# Item 9: Public Hearing on Zoning Ordinance Amendments that Address Technical Edits and Corrections

Justin Horner, Associate Planner  
Planning Commission, July 6, 2022

## **BMC Section 23.204.090 (C-NS Zoning District; Usable Open Space)**

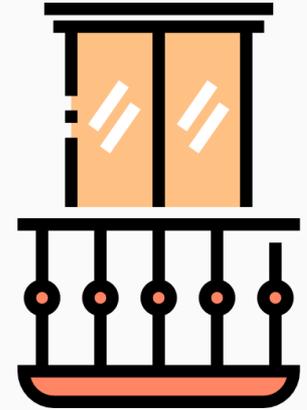
**Policy:** The C-NS District requires 40 sq. ft. of Usable Open Space for each Dwelling Unit.

**Issue:** The new Zoning Ordinance mistakenly includes a requirement of 200 sq. ft. per dwelling unit.

**Amendment:** Revise to include 40 sq. ft. requirement and proper dimension standard.
